Urbicus Ref: URB25-368
Primary Contact: Mark Kierpal

Applicant response to an information request under Section 13 of the Development Assessment Rules

Council reference: A007000493
Property details: 41 Waroon Street, Stafford QLD 4053

Figure 1 – Proposal plan extract

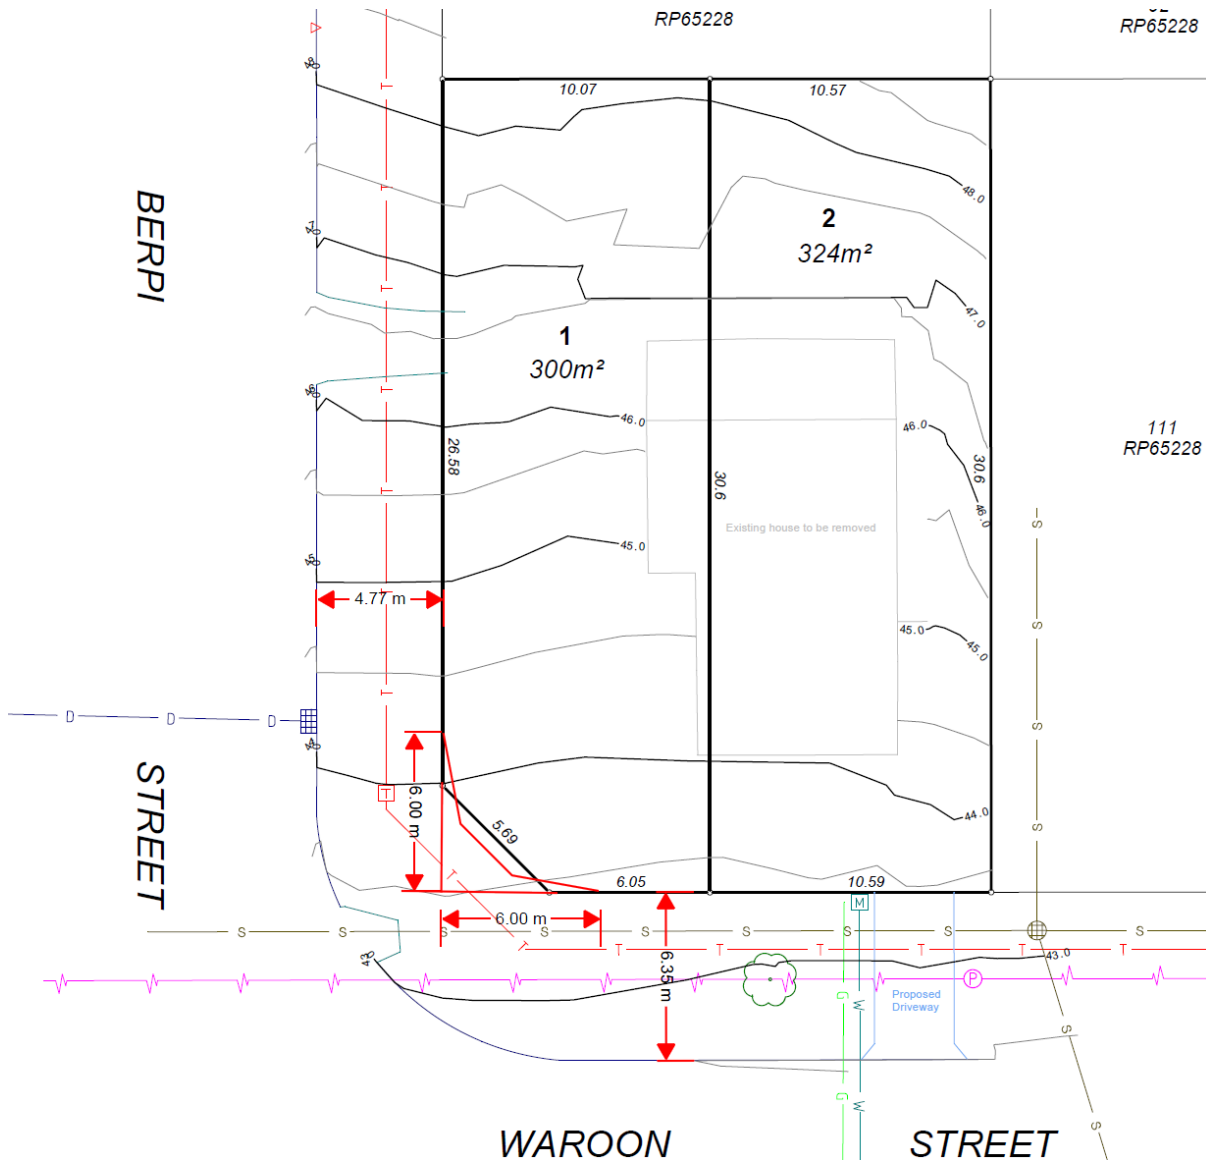
Item	Corner truncation
2	Demonstrate on the amended drawings, provision of a 6.0 metre by 6.0 metre by 3 chord truncation at the corner of Warron and Berpi Streets in order to maintain the safety and efficiency of the external movement network in accordance with the design standards in the Infrastructure Design PSP and as required by the Subdivision Code PO4. Note: the central boundary should be repositioned as needed to ensure both lots remain 300m2+.

In relation to Item 2 we request the status quo remain in terms of the existing truncation. In practical terms, the difference between a 5.69 x 1m corner truncation and a 6m x 3m corner truncation can be considered negligible in circumstances where the adjoining road reserve already contains wider than normal verge widths (4.7m and 6.3m) and achieves good existing sight lines.

Based on the above operational benefit achieved by increasing the truncation area from a 5.69m x 1m arrangement to a 6m x 3m arrangement is negligible or no different in this case as additional truncation area does not materially improve traffic safety outcomes. In concert with the wider verge widths creates additional separation between the carriageway and property boundaries, which effectively increases available sight distance and reduces the functional necessity for larger corner truncations. **Refer to Figure 1.**

Accordingly, from an engineering and planning perspective, a larger 6m x 3m truncation may provide little discernible benefit over a smaller 5.69m x 1m truncation where the surrounding road environment already performs safely and efficiently.
